# DeKalb County Historic Preservation Commission

Monday, August 17, 2026- 6:00 P.M.

## *Staff Report*

F. 1380 Emory Road, Jennifer Witherspoon. Constructing a new garage with an accessory dwelling unit and repairing the landscaping in the back yard. **1248208.**

ELEVATIONS NOTES

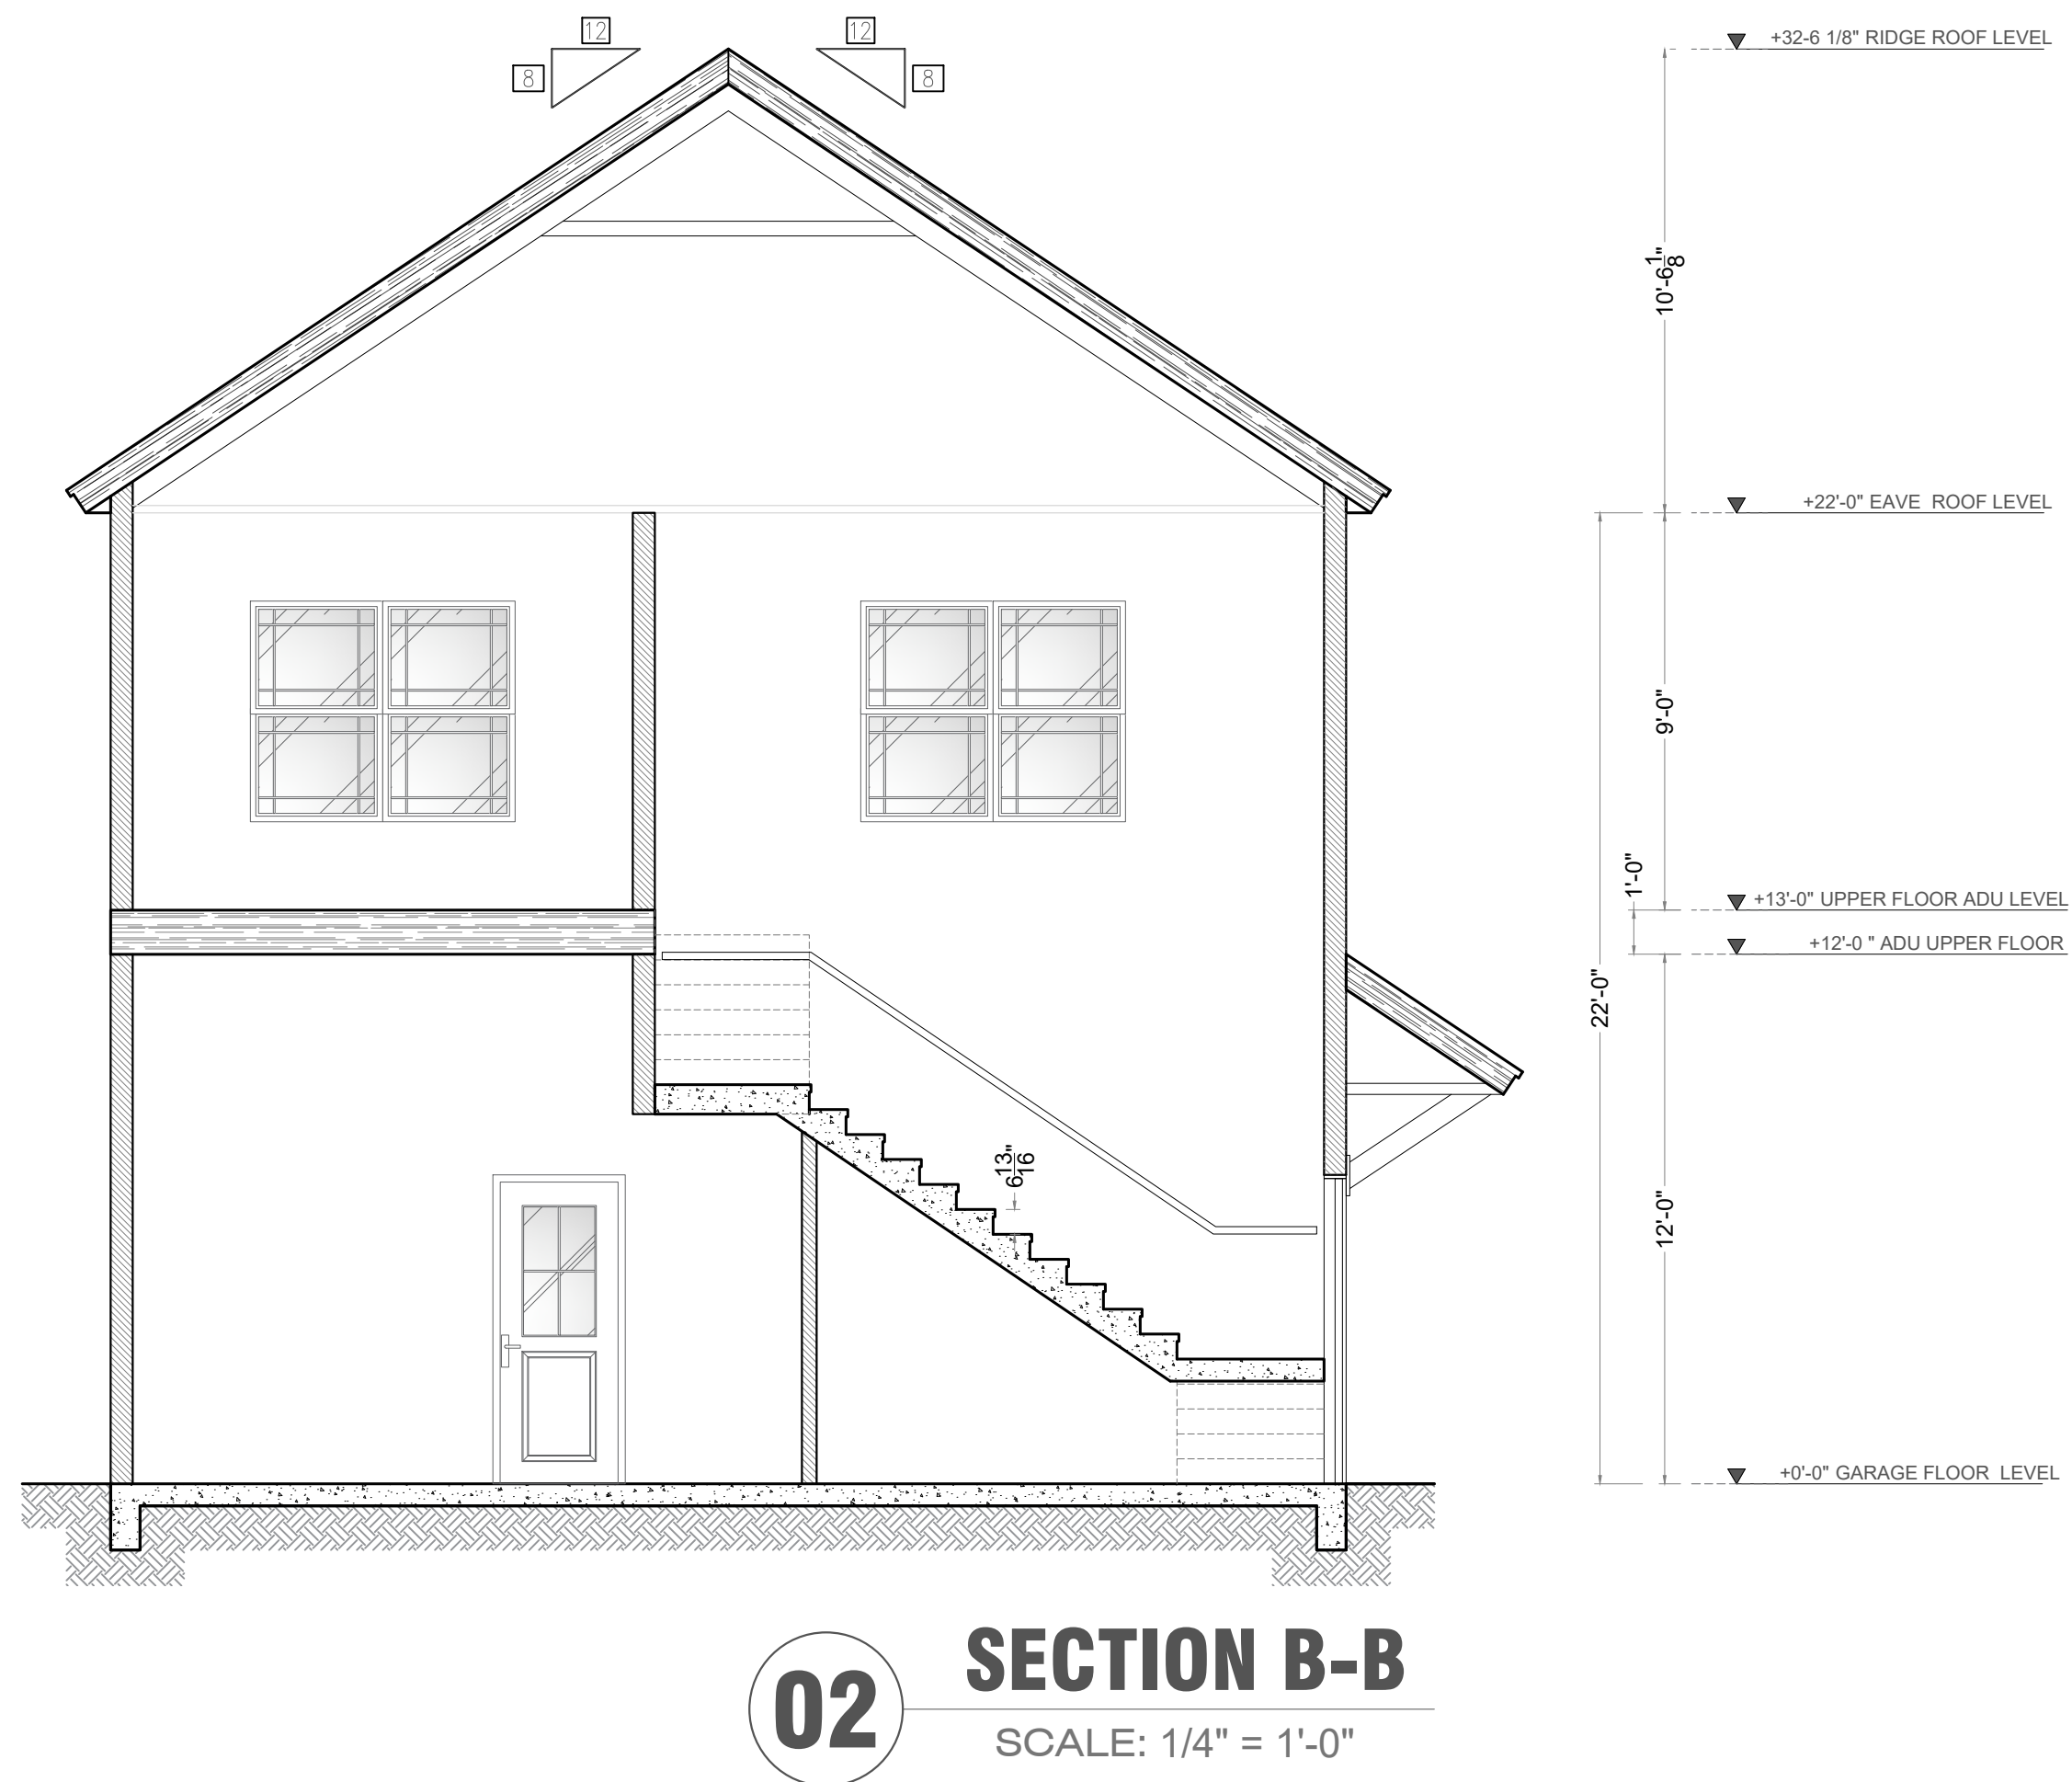
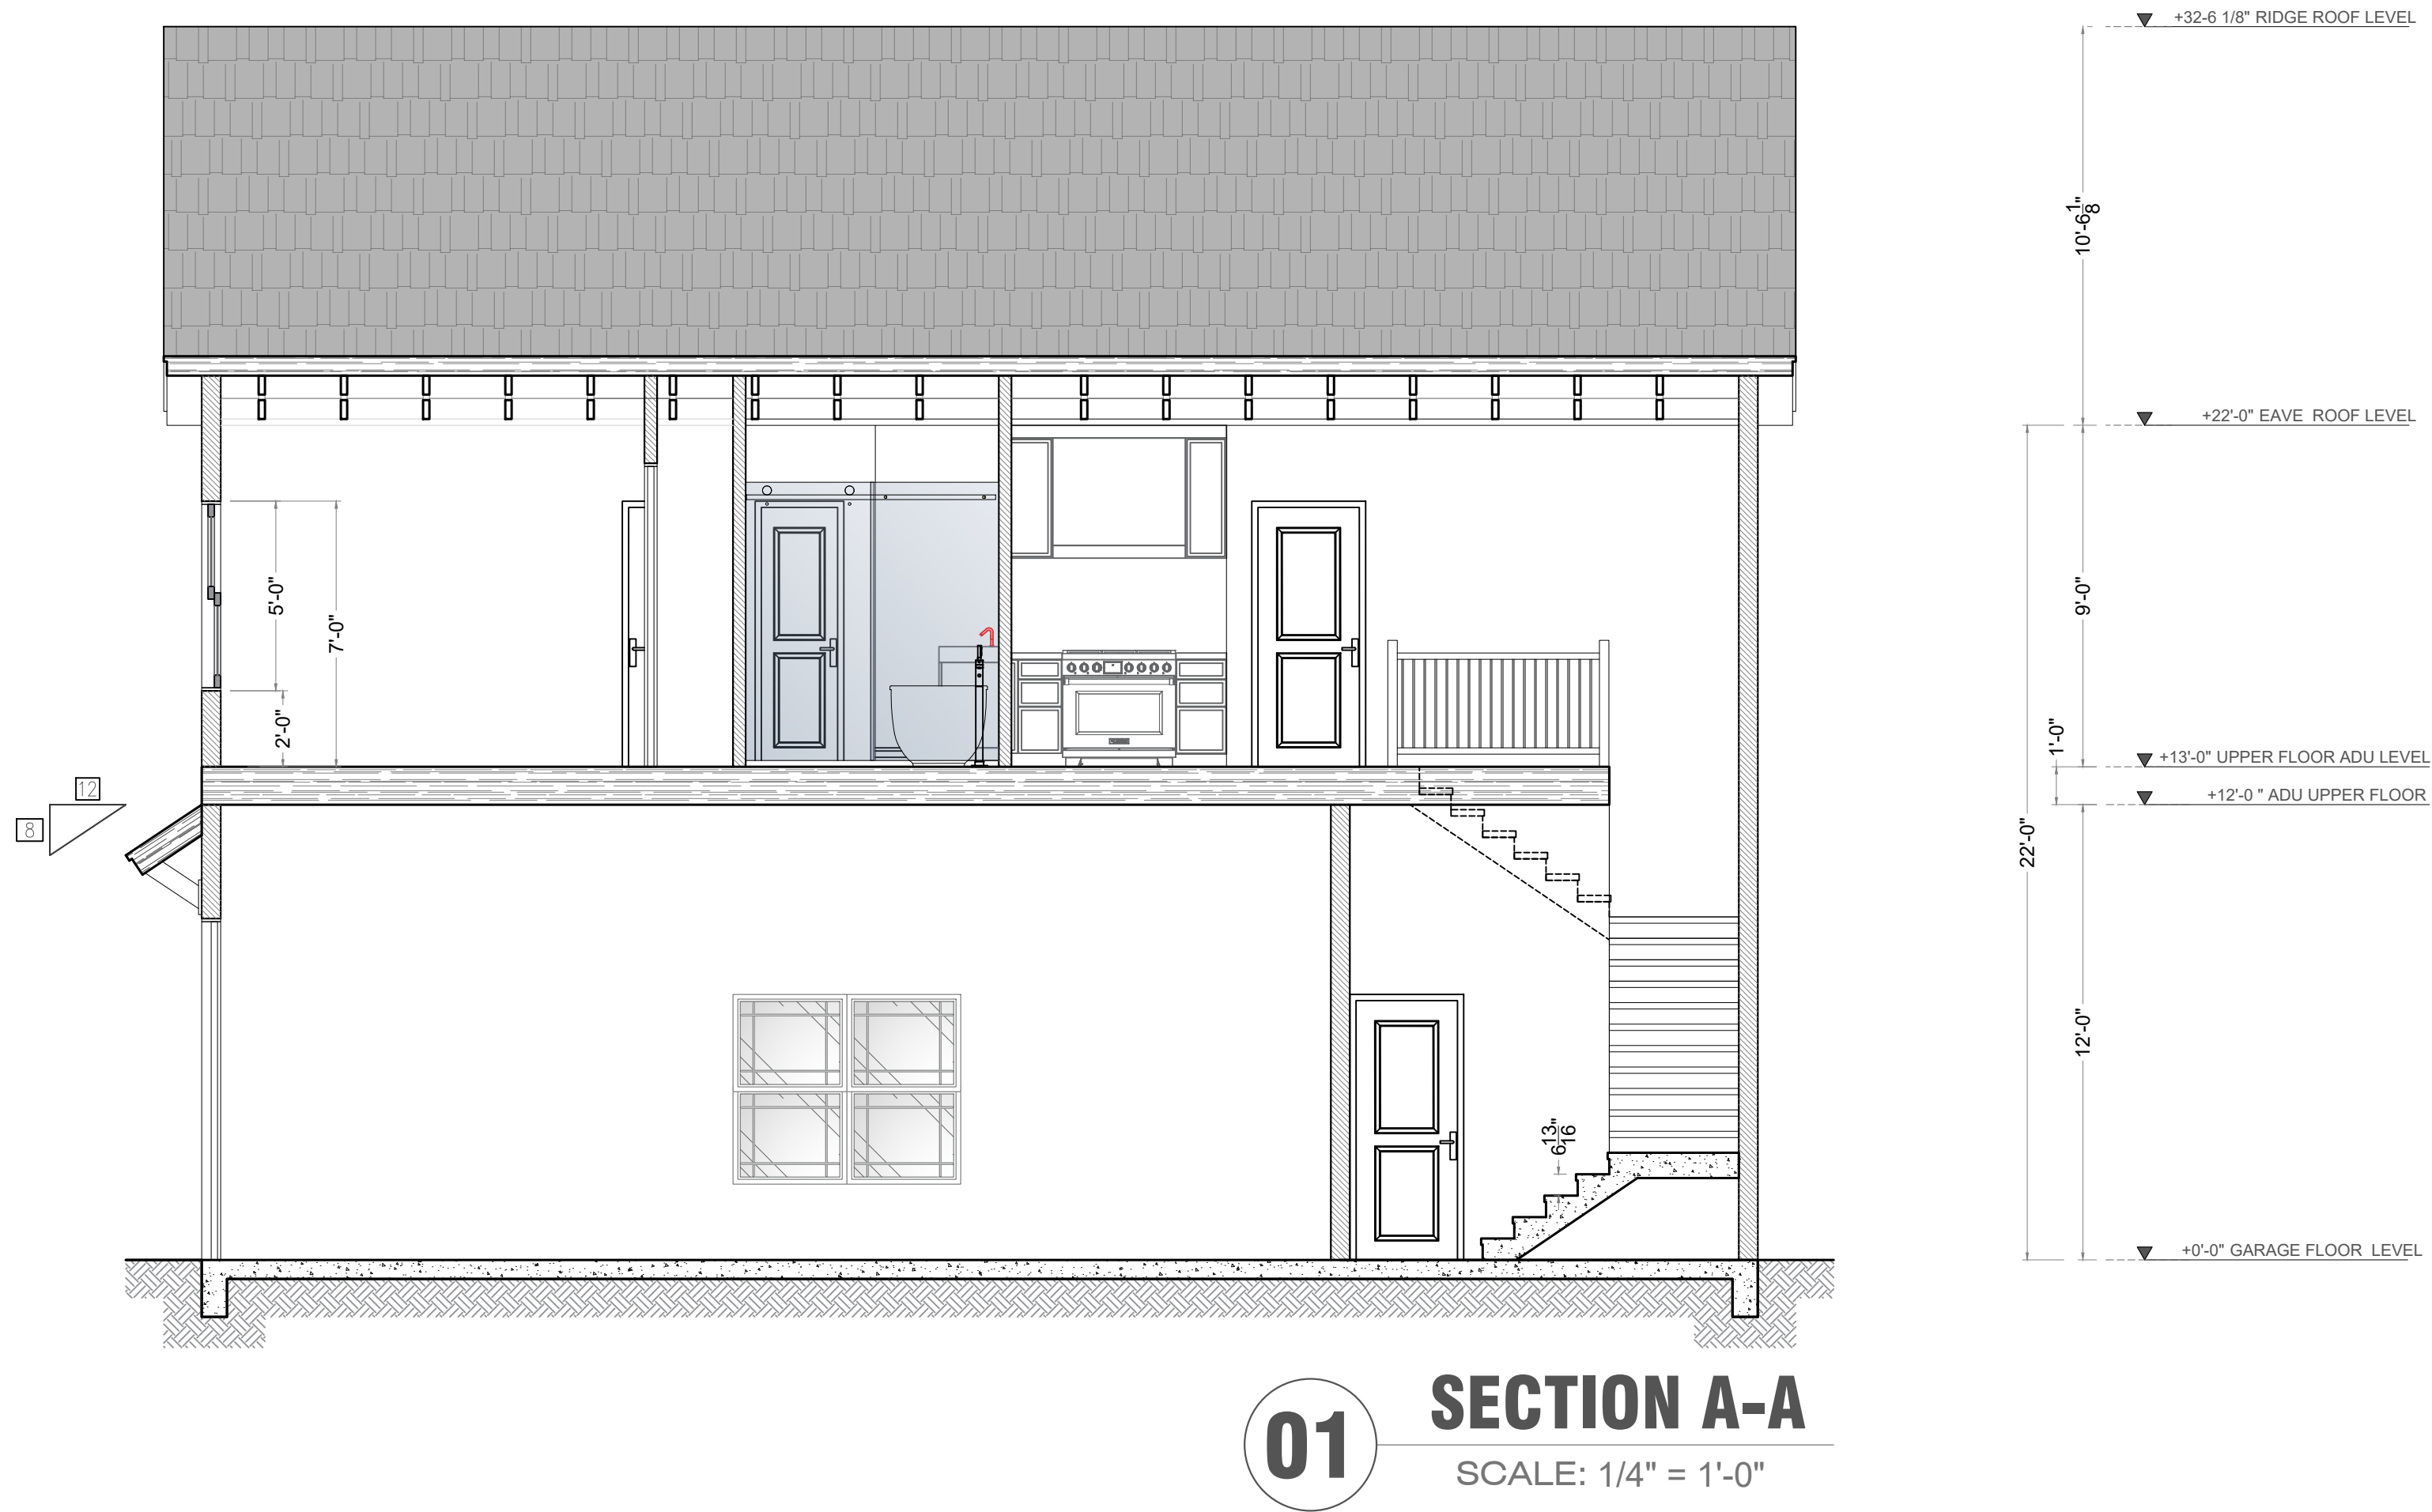
The application was deferred to the next scheduled meeting in order for the applicant to coordinate with staff regarding a mitigation plan for the existing non-complying AC unit<sup>4</sup> and provide plans for review to the Commission. Additionally, more information regarding the proposed accessory structure was requested by Commission members in order to understand the scale of the structure in comparison to the historic house on the property.

Due to proposed height of the accessory structure on the property, a variance will need to be acquired from the Zoning Board of Appeals before a building permit can be issued, as the structure

appears to exceed height requirements for accessory structures on single family detached dwelling properties<sup>5</sup>.

**Approved with Modification.** Staff recommends that the proposed accessory structure and landscaping of the rear yard be approved with the requirement that the existing external AC unit recorded by Code Compliance be removed or that vegetation be installed to mitigate the appearance of the unit from the Right of Way in accordance with Guideline 6.2. The installed vegetation should include plantings from the recommended vegetation list found in Guideline 9.3 of the Druid Hills Design Manual.
